FINAL
ENVIRONMENTAL IMPACT REPORT

Santa Clara Square

PLN2003-04079 and CEQ2003-01015

February 8, 2008

Shadow Diagrams – Summer

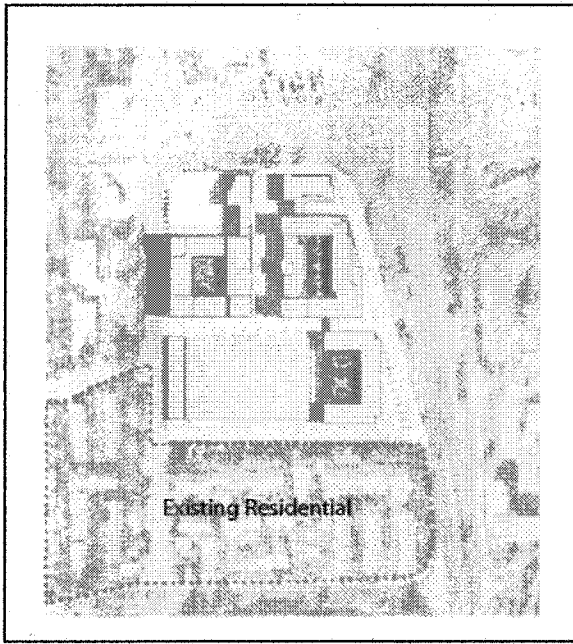
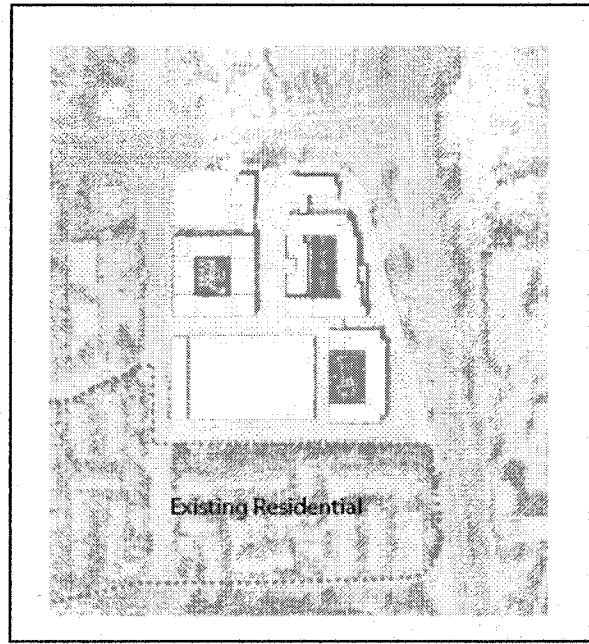
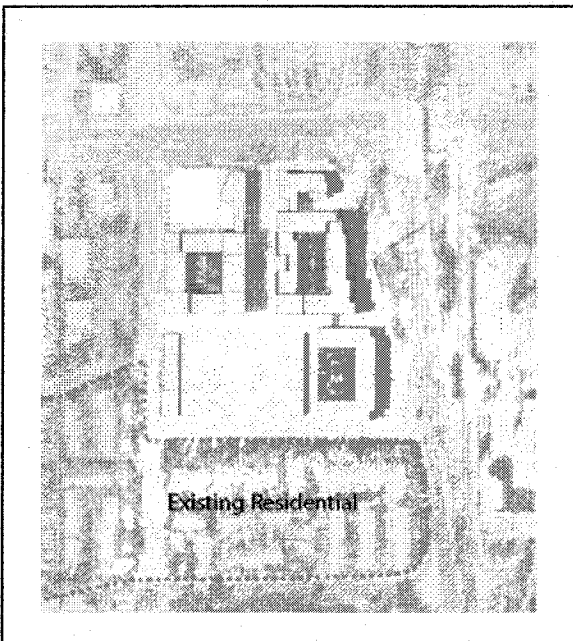
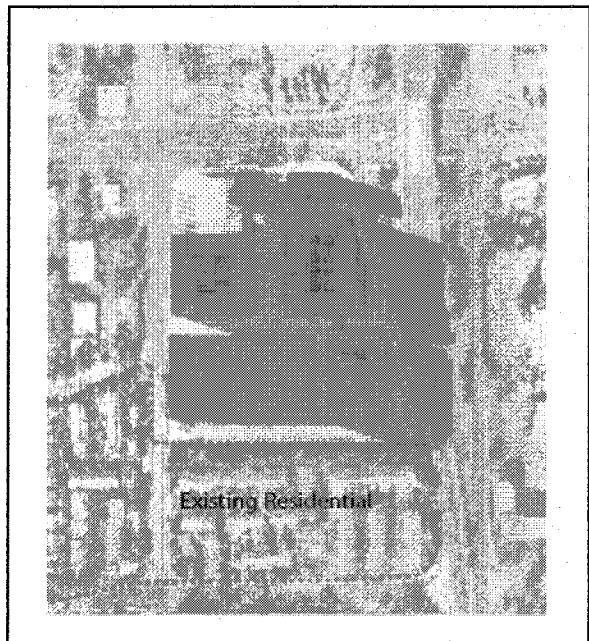
The proposed buildings are located north of existing residential units and, as shown on the following Shadow Diagrams, shadows from the buildings would never shade the adjacent residential area and would not block light to the units. The proposed buildings would be visible from the second-floor levels of the existing residential units, although the views would be fully or partially screened by the existing and proposed trees, as shown in the following photographs. Additional trees are proposed to fill in the empty spaces. The proximity of a mature tree screen will affect extended views to a similar degree as multi-story structures.

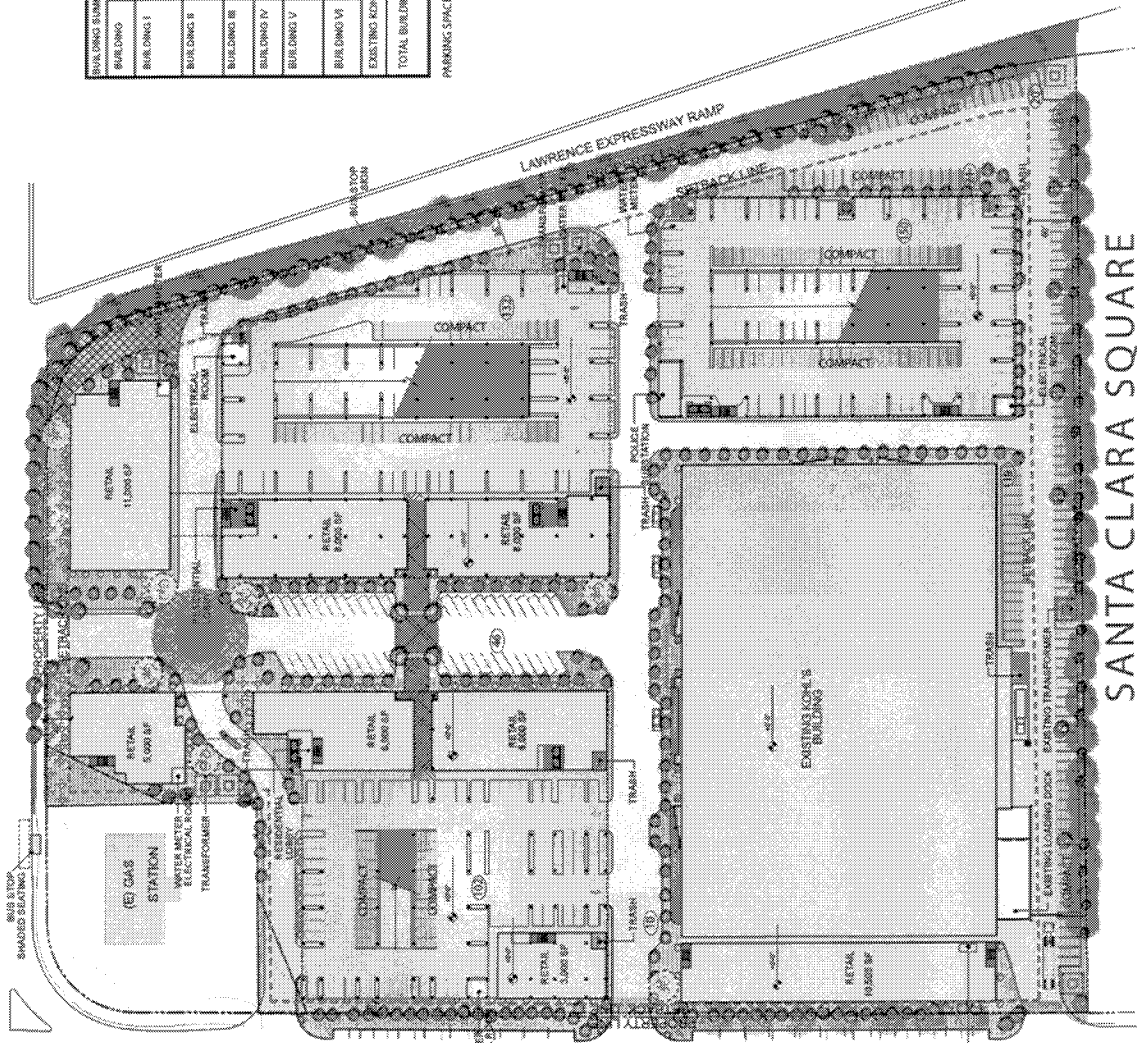
pages 19, 20 and 21 Replace the First Level Plan, Figure 11; Fifth Level Plan, Figure 12; and Eighth Level Plan, Figure 13 with the following plans.

X – Trees to be Removed

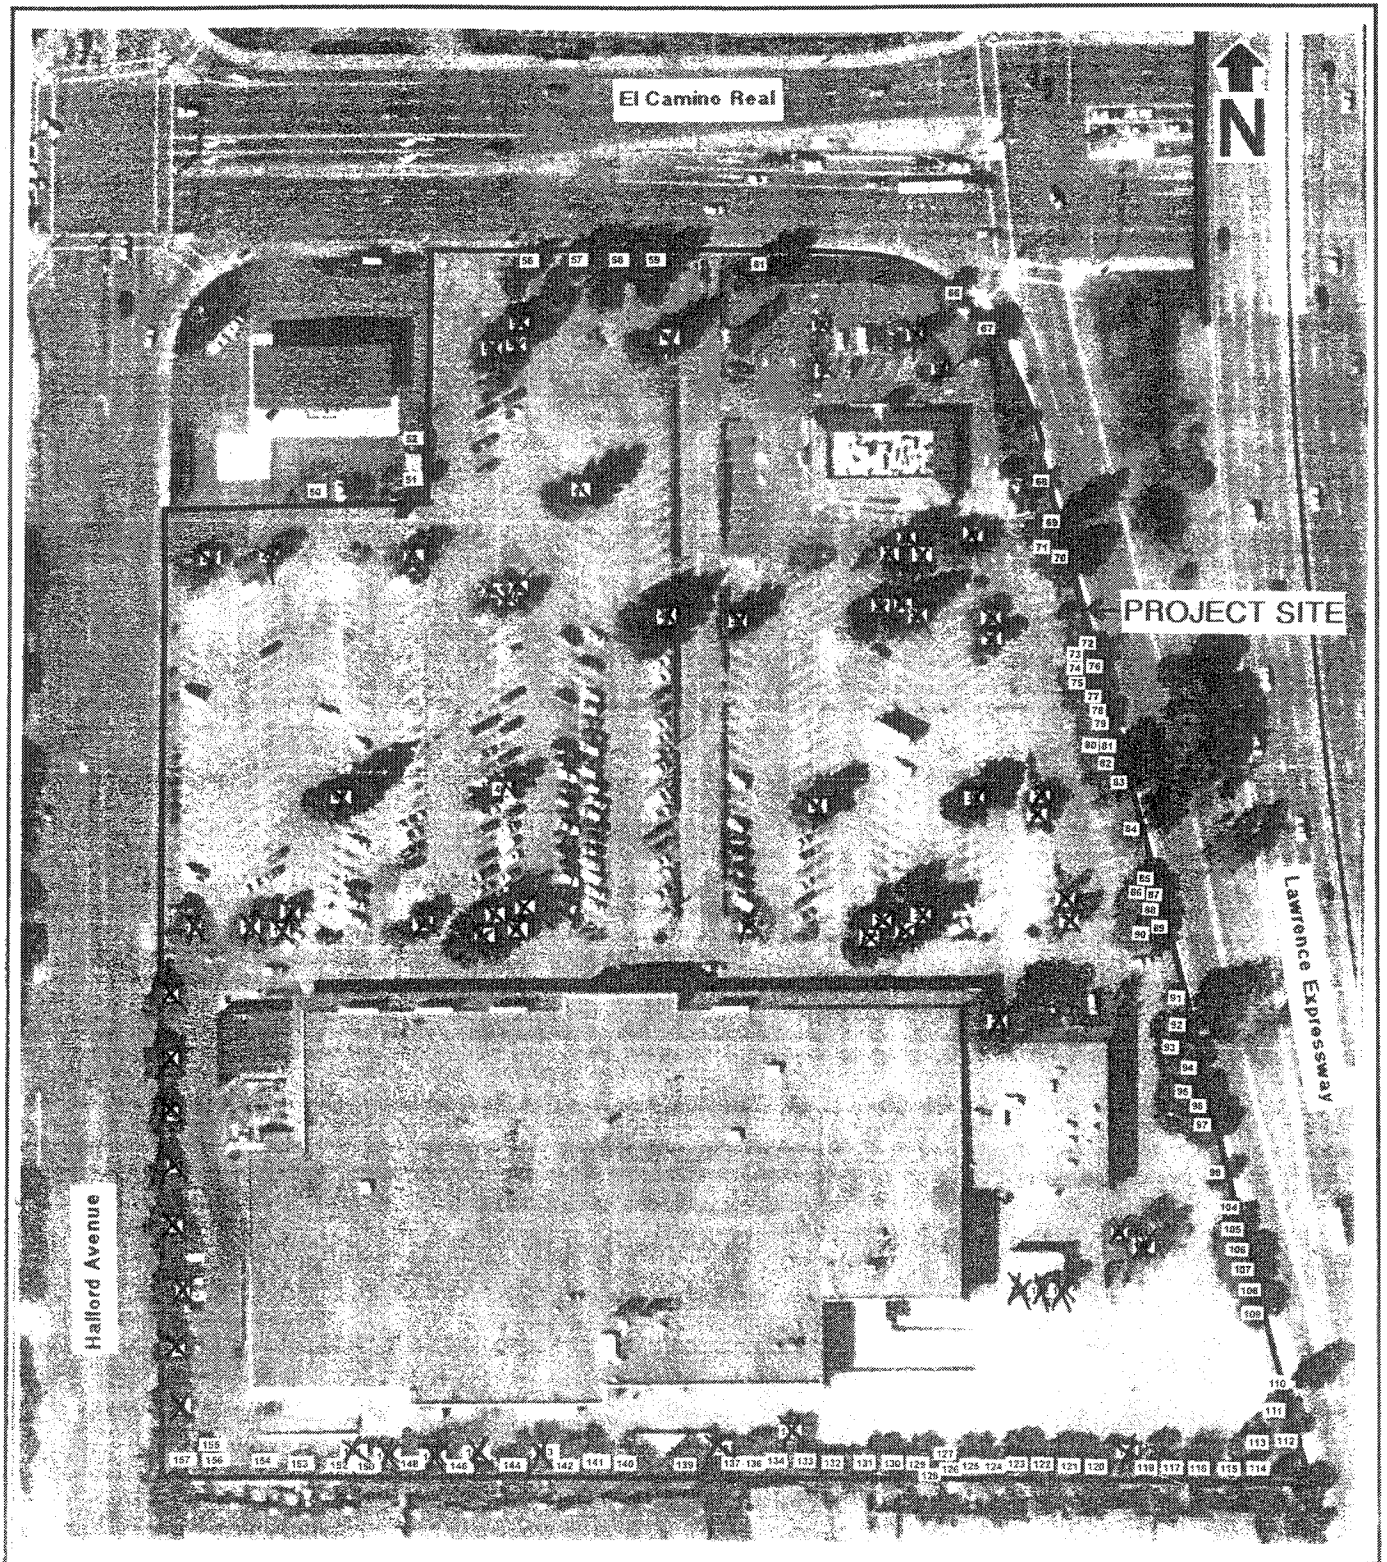
The row of Canary Island Pine trees located along Halford Avenue, which were originally planted to screen the auto service bays of a previous use, are to be removed. A two-story retail/office building is planned at that location, and new trees will be planted along the street frontage. The row of trees along the southerly property line are not planned to be removed, as shown on the Existing Trees table and Trees to be Removed map in the Technical Appendix of the Draft EIR. See Text Amendments.

Tree Nos. 1 – 8 added to removal list.
